Interactive comment on “A technical description of the Balloon Lidar Experiment BOLIDE” by Bernd Kaifler et al.

Bernd Kaifler et al.

Received and published: 2 June 2020

Fig. 2.

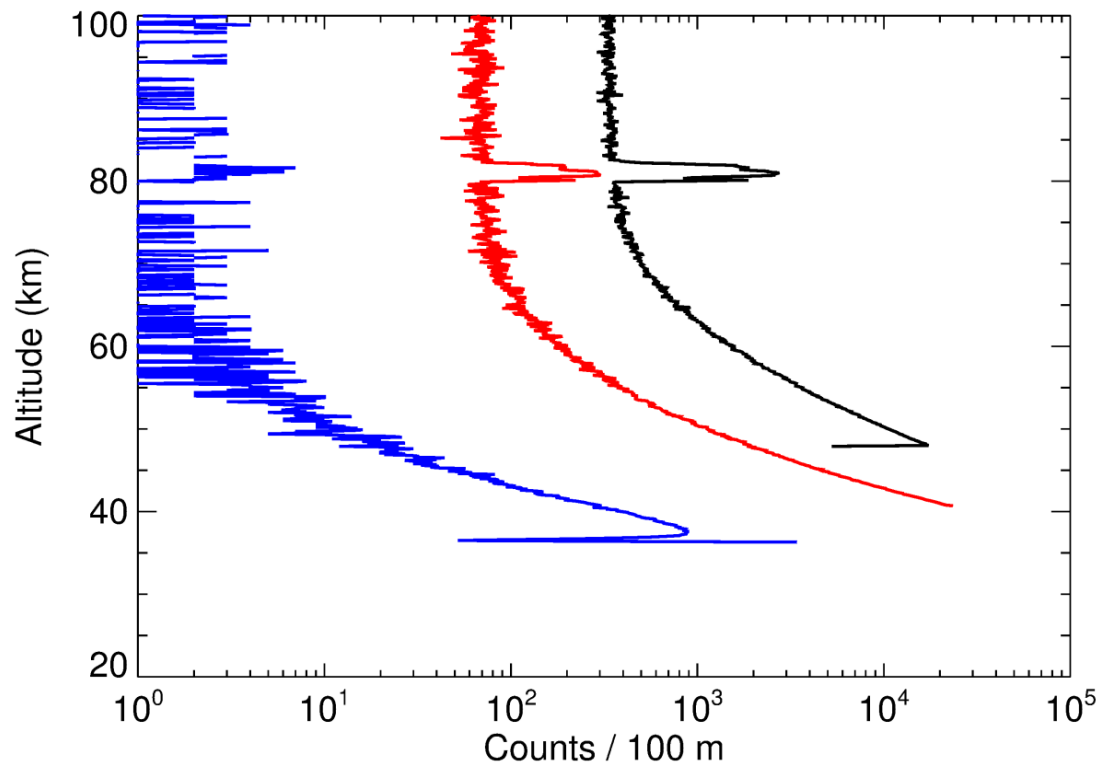
In our case a single detector was sufficient to handle the PMC backscatter signal. However, with the BOLIDE instrument we also wanted to measure Rayleigh temperature profiles below the PMC layer, reaching down as close as possible to the balloon gondola. Figure 2 shows photon count profiles from all three detectors (APD1 (black), APD2 (red), PMT (blue); the gondola was at approximately 37 km altitude). It turned out that defocusing of the telescope in the near field rendered the lower 5–8 km of the profiles useless and, as a result, the third detector exhibited much lower counting rates at low altitudes than anticipated.
